UNITED STATES PATENT AND TRADEMARK OFFICE

APPLICATION NO.	FILING DATE	FIRST NAMED INVENTOR	ATTORNEY DOCKET NO.	CONFIRMATION NO.
10/516,713	12/01/2004	Wolfgang Schnitt	DE02 0137 US	6751

Office Action Summary	Application No. 10/516,713	Applicant(s) SCHNITT ET AL.	
	Examiner Benjamin T. Liu	Art Unit 2826

DETAILED ACTION

Figure 1: semiconductor device with first passivation layer 2A and silicon substrate 1A

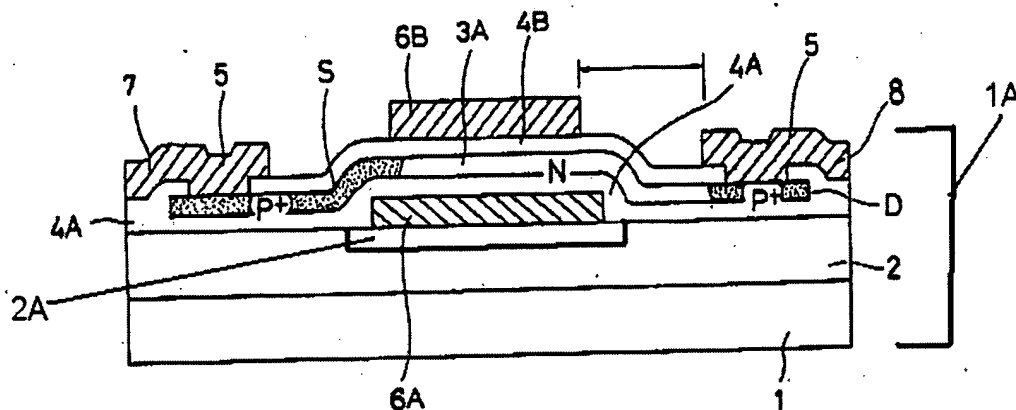
With regard to claim 1, figure 3 of Adan discloses a semiconductor-on-insulator (SOI) device, comprising: at least one isolating layer 1 made of a dielectric material; at least one silicon substrate 1A arranged on said isolating layer 1; at least one component (S, 3A, D) integrated in the silicon substrate 1A, which component (S, 3A, D) has at least one slightly doped zone 3A laterally situated between a first highly doped zone S

and a second highly doped zone D; as well as at least a first, planar, metallization region 6A arranged between the isolating layer 1 and the component (S, 3A, D), between the isolating layer 1 and the slightly doped zone 3A of the component (S, 3A, D), characterized in that at least a second, in particular planar, metallization region 6B is arranged on the side of the silicon substrate 1A facing away from the isolating layer 1, in the area of the component (S, 3A, D), in the area of the slightly doped zone 3A of the component (S, 3A, D).

With regard to claim 2, figure 3 of Adan discloses a semiconductor device, characterized in that the silicon substrate 1A comprising the component (S, 3A, D) is fixed onto the isolating layer 1 with at least one fixing medium 2, with an adhesive layer.

With regard to claim 3, figure 3 of Adan discloses a semiconductor device, characterized in that the first highly doped zone S, the slightly doped zone 3A and the second highly doped zone D form at least one bipolar pnp transistor in the component;

and the slightly doped zone 3A of the component (S, 3A, D) forms the n-doped region 3A of the pnp transistor. (Note lines 13-16 in column 4 of Adan)

With regard to claim 4, figure 3 of Adan discloses a semiconductor device, characterized in that the first metallization region 6A is embedded in at least a first, oxide-based, passivation layer 2.

With regard to claim 5, figure 3 of Adan discloses a semiconductor device, characterized in that on the side of the component (S, 3A, D) facing the isolating layer 2, at least one oxide layer 4A borders on at least the component (S, 3A, D) or on the first passivation layer 2A.

With regard to claim 6, figure 3 of Adan discloses a semiconductor device, characterized in that between the component (S, 3A, D) and the second metallization region 6B at least a second, oxide-based passivation layer 4B, is arranged.

With regard to claim 7, figure 3 of Adan discloses a method of manufacturing at least one semiconductor device, in particular, wherein: at least one isolating layer 1 made of a dielectric material is provided with at least one silicon substrate 1A using, adhesive means; at least one component (S, 3A, D) having, at least one slightly doped zone 3A laterally situated between a first highly doped zone S and a second highly doped zone D, integrated in the silicon substrate 1A; and at least a first planar metallization region 6A is arranged between the isolating layer 1 and the slightly doped zone 3A of the component (S, 3A, D), characterized in that at least a second planar metallization region 6B is provided on the side of the silicon substrate 1A facing away

from the isolating layer a, in the area of the slightly doped zone 3A of the component (S, 3A, D).

With regard to claim 8, figure 3 of Adan discloses a method, characterized in that the first metallization region 6A is embedded in at least a first, oxide-based passivation layer 2A.

With regard to claim 9, figure 3 of Adan discloses a method, characterized in that at least a second buried oxide-based passivation layer 4B is arranged between the component (S, 3A, D) and the second metallization region 6B.

With regard to claim 10, figure 3 of Adan discloses an application of at least a first, planar, metallization region 6A as well as at least a second, planar, metallization region 6B to electrically shield, on both sides, at least a component (S, 3A, D) incorporated in the silicon substrate 1A of a SOI device, to electrically shield, on both sides, at least a slightly doped zone 3A of the component (S, 3A, D).
